Service Bulletin

Bulletin No.: 24-NA-065

Subject: Chirp Noise from Center Stack/Radio Control

Brand:	Model:	Model Year:		VIN:		Engine:	Transmission:
		from	to	from	to		
BrightDrop	Zevo 600	2023	2023	-	-	All	All

6596308

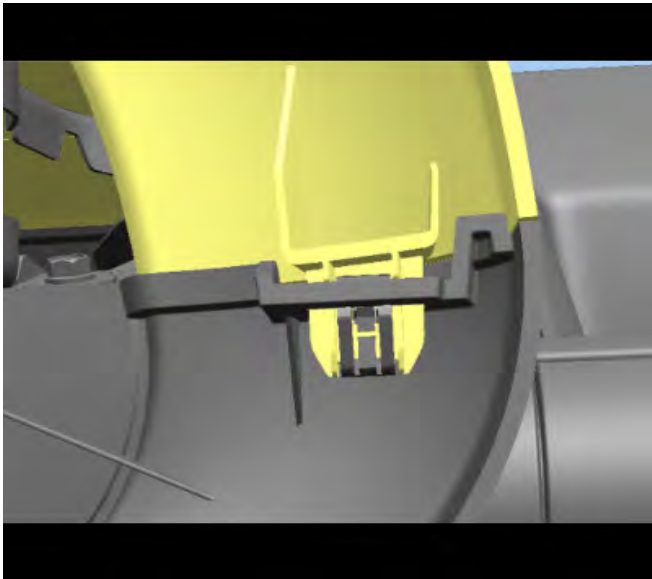
1. Using a non-marring tool, remove the Radio Control cover. Refer to *Radio Control Replacement* in Si.

6596309

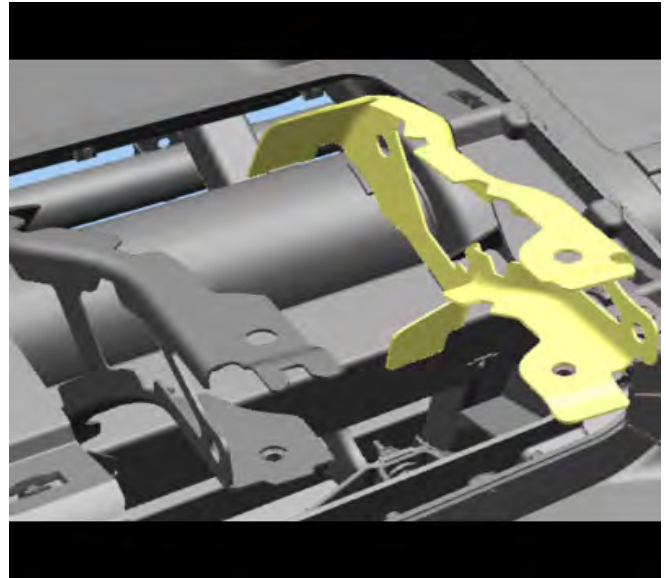
The radio control top cover is affixed using clips and can be popped off using trim stick.

Note: Not pictured is the ICS screen, screen does not need to be removed to complete repair.
